Project	IEEE 802.16 Broadband Wireless Access Working Group < http://ieee802.org/16 >	
Title	Definition of octets present in VLAN Convergence Sublayer.	
Date Submitted	2005-03-17	
Source(s)	Mike Geipel Axxcelera 1600 East Parham Road Richmond VA 23228	Voice: 804-864-4125 Fax: mailto: geipel @ ieee,org
Re:	Working group letter ballot 17, call for comment on "P80216_Cor1_D1.pdf" dated 2005-02-11.	
Abstract	Definition of Octets present in VLAN Convergence Sublayer.	
Purpose	Available to support a comment in the commentary database. Adopt changes	
Notice	This document has been prepared to assist IEEE 802.16. It is offered as a basis for discussion and is not binding on the contributing individual(s) or organization(s). The material in this document is subject to change in form and content after further study. The contributor(s) reserve(s) the right to add, amend or withdraw material contained herein.

Definition of Octets Present in VLAN Convergence Sublayer

Mike Geipel
Axxcelera

Untagged Frames

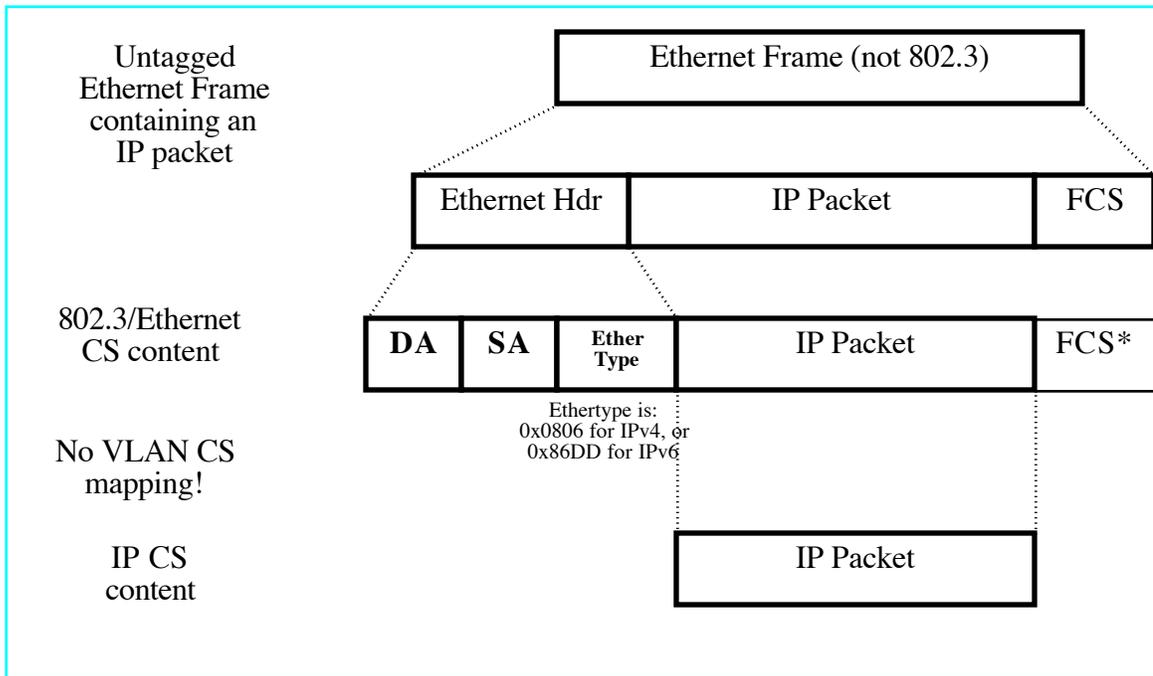
Note that the 802.16 VLAN classifiers are defined such that they cannot match untagged frames.

.The EtherType is still there as protocol discriminator. Of course, in the more likely cases may be IPv4-over-VLAN or IPv6-over-VLAN, where the encapsulated layer-3 protocol is already know.

802.3 Tagged Frames with LLC/SNAP Encapsulation

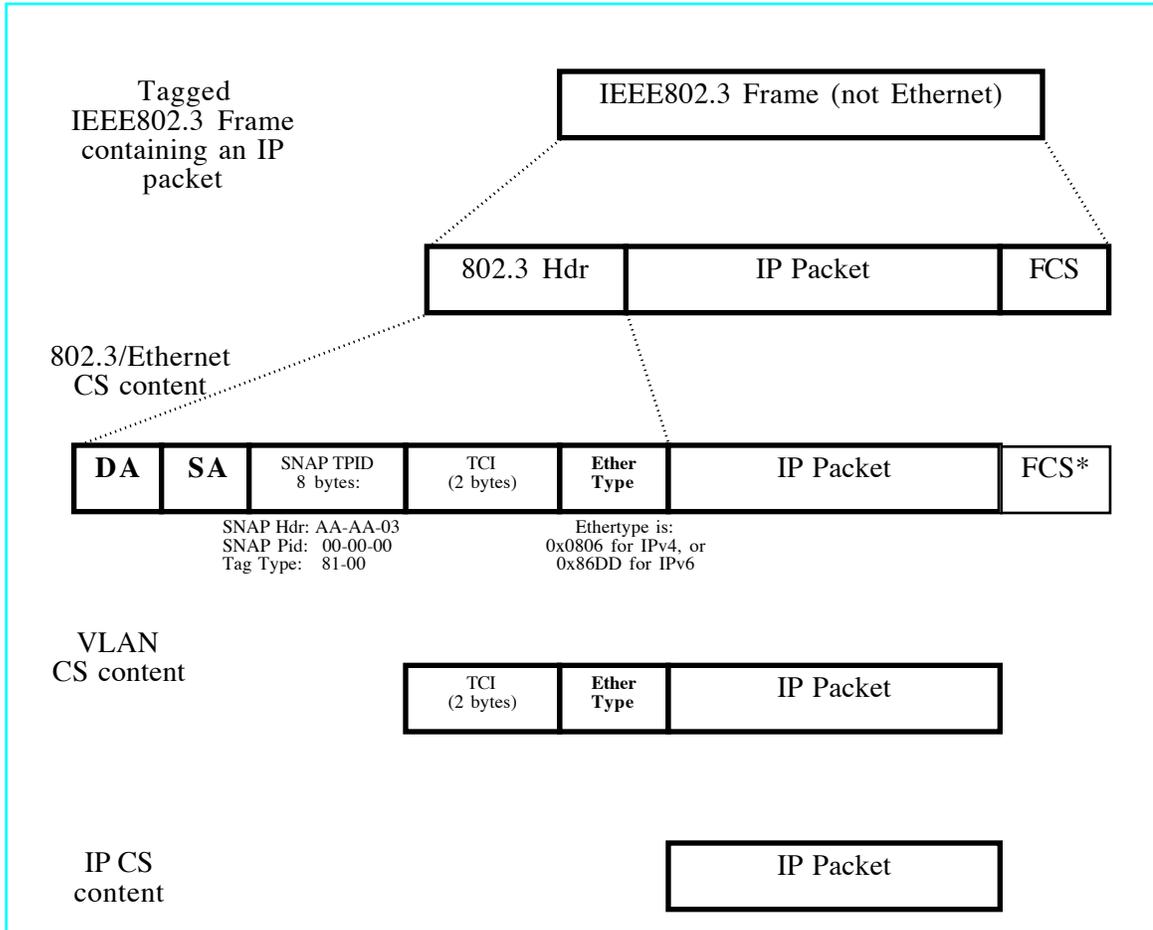
Note that the VLAN frame that is left over, after Ethernet's DA, SA and TPID were stripped off, is the same as in the previous example.
